Response to Draft Report: 2019 Benchmark Reserve Capacity Price for the 2021-22 Capacity Year

Merredin Energy Pty Ltd (**MEPL**) owns and operates the 82 MW open cycle gas turbine power station located in Merredin, Western Australia. The financial performance of the plant is highly dependent on the revenue earned by providing Capacity Credits under the Reserve Capacity Mechanism (**RCM**). The level of the Benchmark Reserve Capacity Price (**BRCP**) has the potential to significantly impact the revenue received by MEPL in 2021-22, as well as impact the incentives for new plant entry in the South West Interconnected System (**SWIS**).

Figure 1: Market Risk Premiums and BBB corporate bond spread

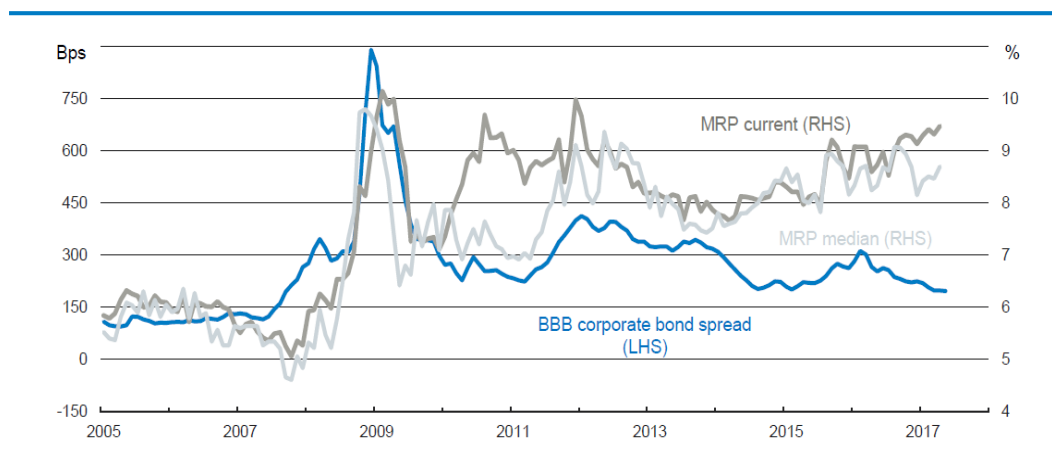
A Market Risk Premium (MRP) of 6 percentage points is added to the current inflation rate to determine the return to equity holders. While 6 percentage points reflects the long run risk premium associated with power station finance³ it doesn't reflect the risks associated with financing a power station today. As shown below, IPART has calculated that the MRP exceeds 8 per cent in recent years.

IPART's approach is to calculate WACCs based on both the long term MRP (6 per cent) and the current MRP (8.3 per cent), and then use the mid-point of short term and long term WACC estimates in the assessment of regulatory pricing.

Given that the current market risk premium currently exceeds 8 per cent (mainly due to the lower risk-free rate of debt), we suggest that the MRP used by AEMO in the calculation of the BRCP should be increased to 7 per cent.
